**BUNTING MULTIFAMILY  
 SITE DEVELOPMENT PLAN**

**SITE PLAN**

**DP-2** MVE PROJECT 61072  
 MVE DRAWING -DEV-SP

# Site Plan\_V2\_redlines.pdf Markup Summary

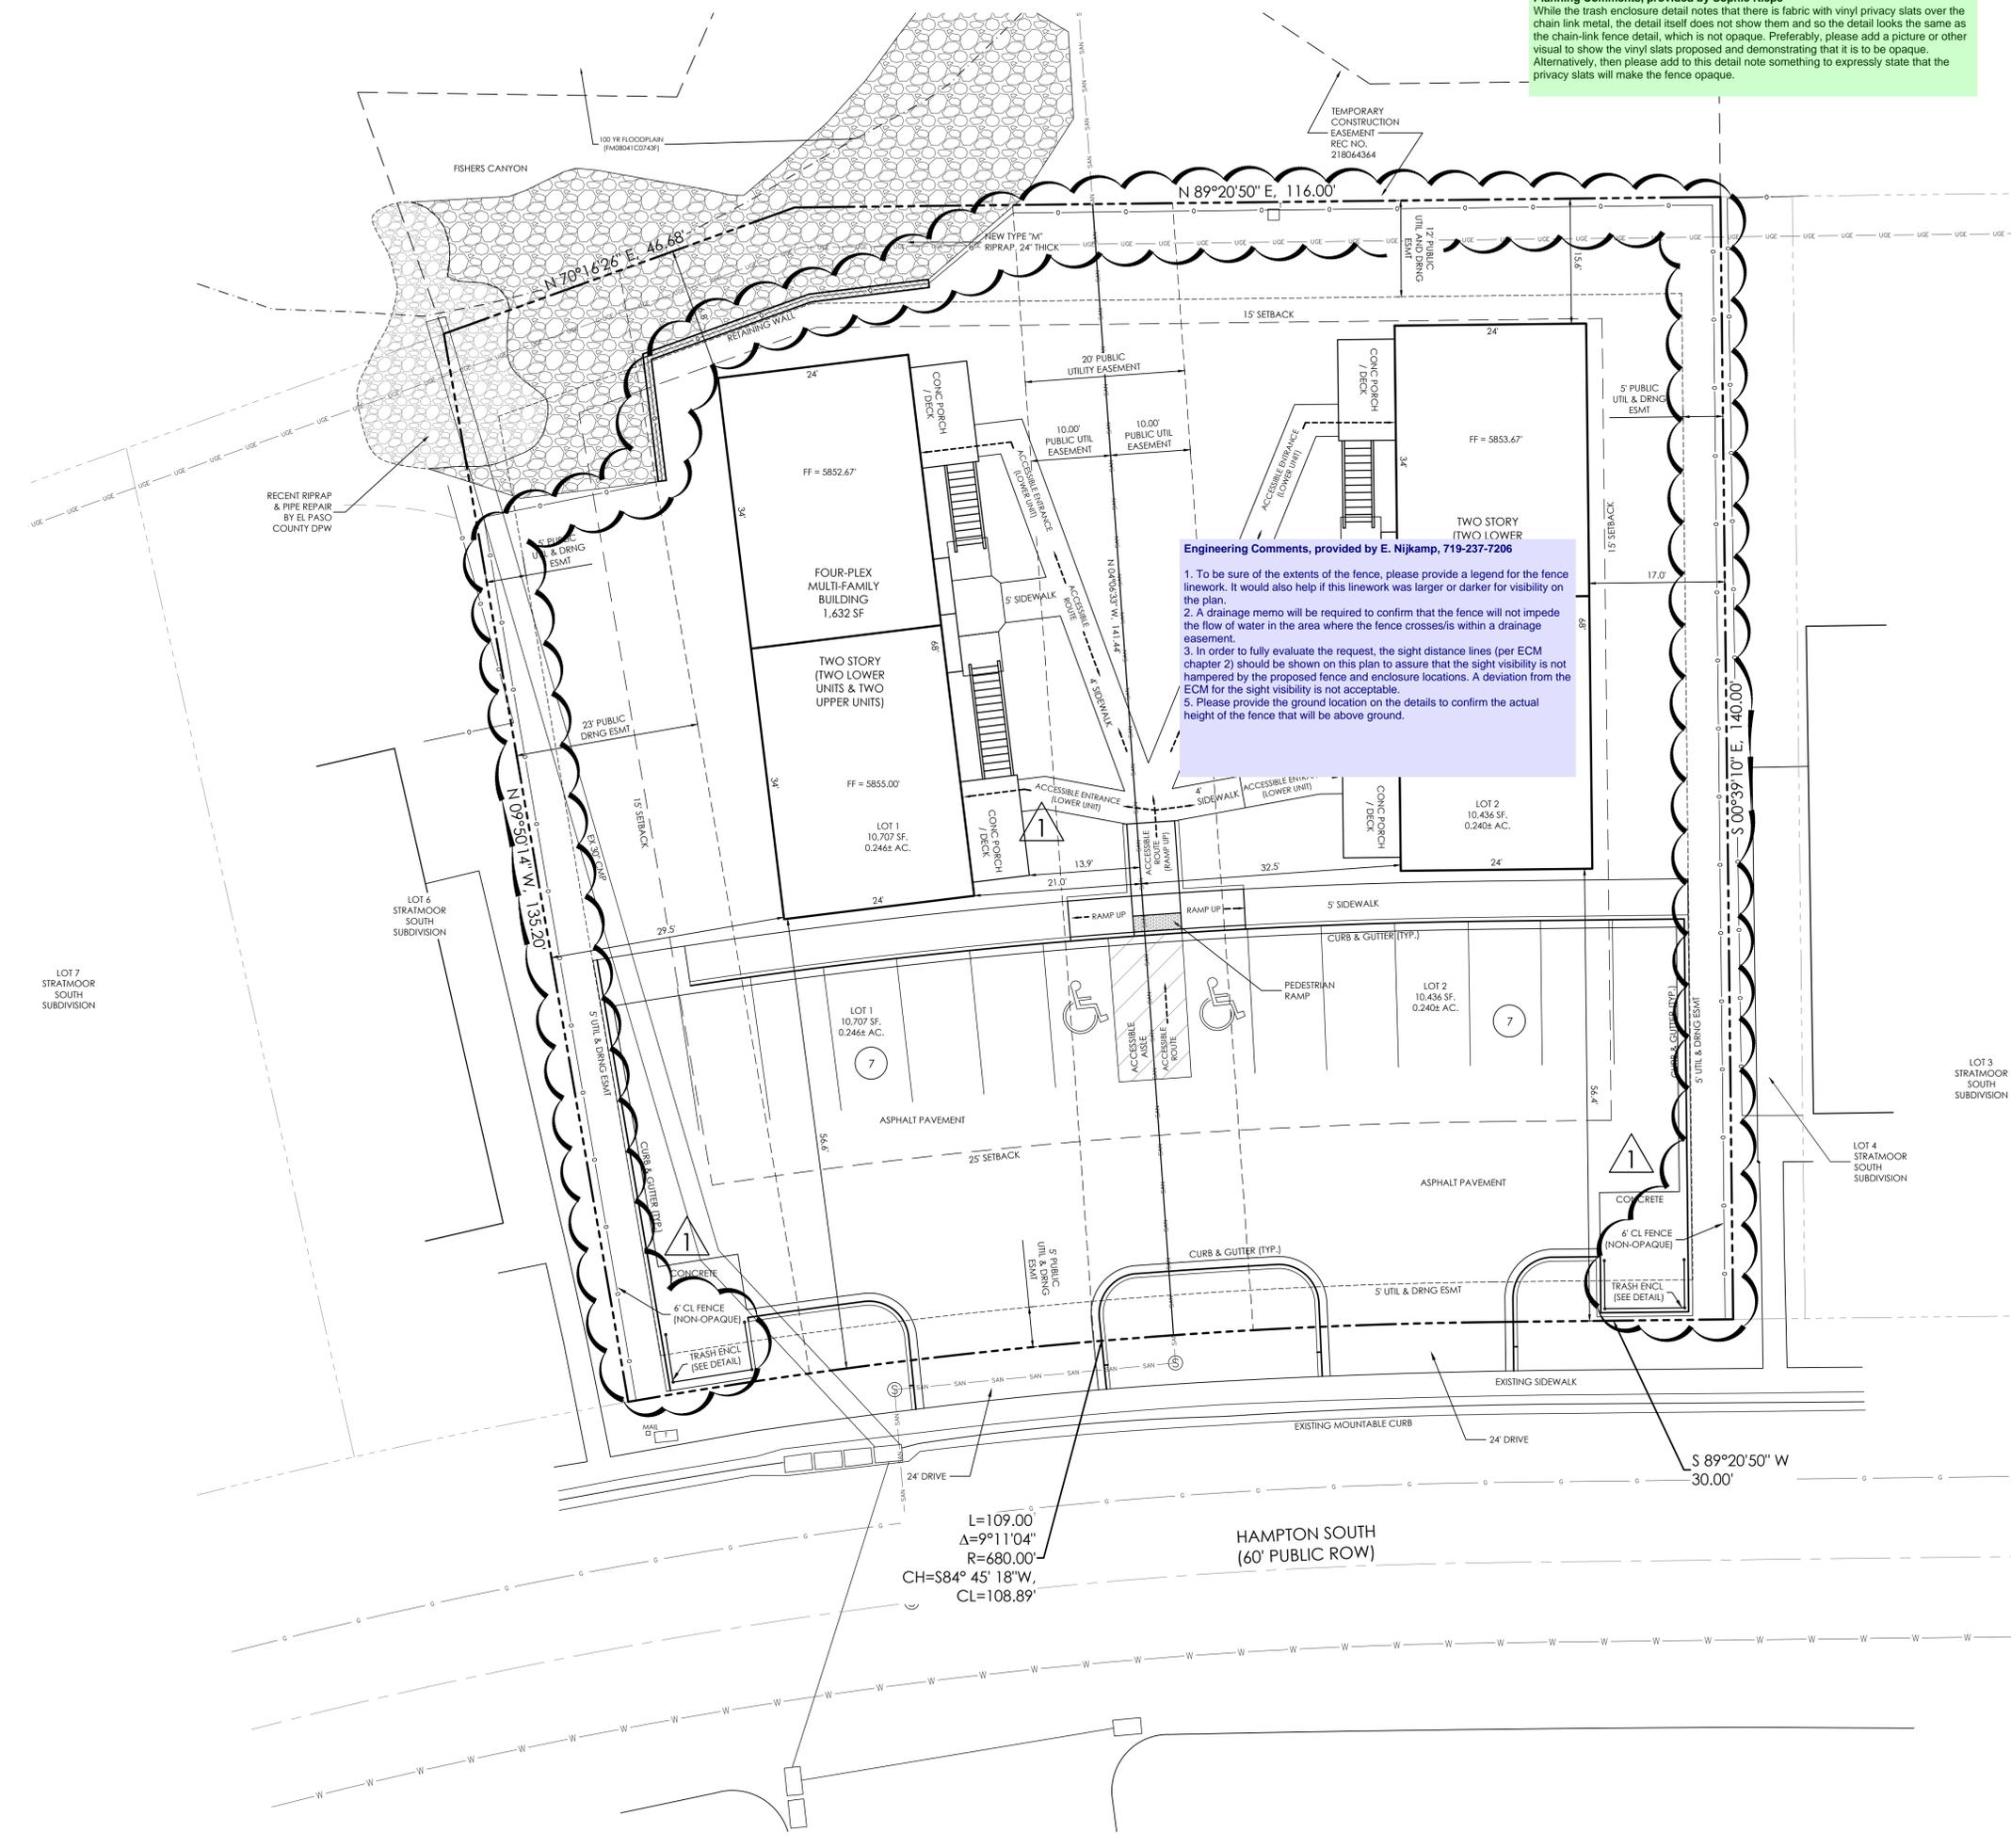
**Planning Comments, provided by Sophie Kiepe**  
 While the trash enclosure detail notes that there is fabric with vinyl privacy slats over the chain link metal, the detail itself does not show them and so the detail looks the same as the chain-link fence detail, which is not opaque. Preferably, please add a picture or other visual to show the vinyl slats proposed and demonstrating that it is to be opaque. Alternatively, then please add to this detail note something to expressly state that the privacy slats will make the fence opaque.

1. To be sure of the extents of the fence, please provide a legend for the fence linework. It would also help if this linework was larger or darker for visibility on the plan.
2. A drainage memo will be required to confirm that the fence will not impede the flow of water in the area where the fence crosses/is within a drainage easement.
3. In order to fully evaluate the request, the sight distance lines (per ECM chapter 2) should be shown on this plan to assure that the sight visibility is not hampered by the proposed fence and enclosure locations. A deviation from the ECM for the sight visibility is not acceptable.
4. Please provide the ground location on the details to confirm the actual height of the fence that will be above ground.
